SB26030077 NEW LONG MAINTENANCE KIT IVECO DAILY 2.3 KC25070619E

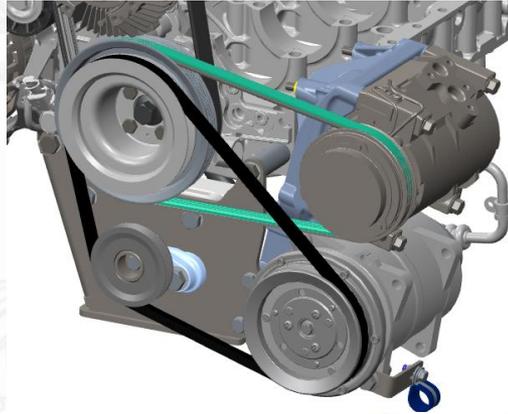
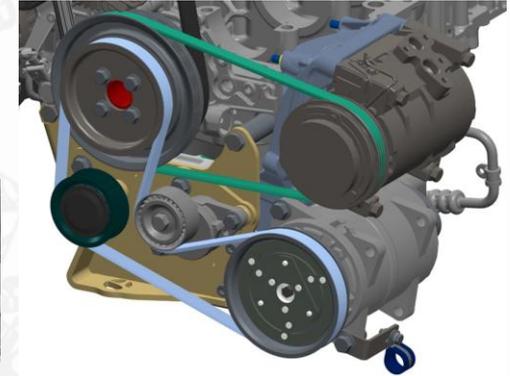
Km (miles)	Working hours	Process		Process Time
5.000 (3.100)	100	Operation A	Check belt tension	15 min
30.000 (18.600)	600	Operation A	Check belt tension	15 min
50.000 (31.000)	1.000	Operation B	Change belt	Parts required: 1260200930 30 min
55.000 (34.100)	1.100	Operation A	Check belt tension	15 min
80.000 (50.000)	1.600	Operation A	Check belt tension	15 min
100.000 (62.000)	2.000	Operation C	Change belt and pulleys	Parts required: 1185010465 45 min

Km (miles)	Working hours	Process		Process Time
50.000 (31.000)	1000	Operation A	Change belt	Parts required: Ref. 1260501123 15 min
100.000 (62.000)	2000	Operation B	Change belt and pulleys	Parts required: Ref. 1185010619 30 min

With the new long-maintenance kit, vehicles spend less time in the workshop.

SB26030077 NEW LONG MAINTENANCE KIT IVECO DAILY 2.3 KC25070619E

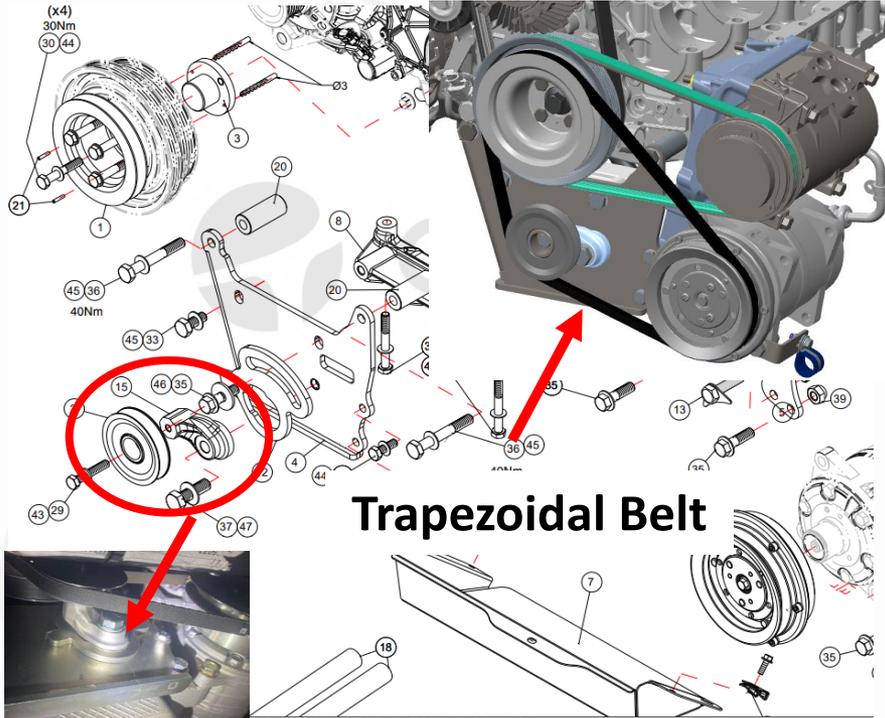
Trapezoidal Belt

KC18070465E

KC25070619E

Poly-V Belt
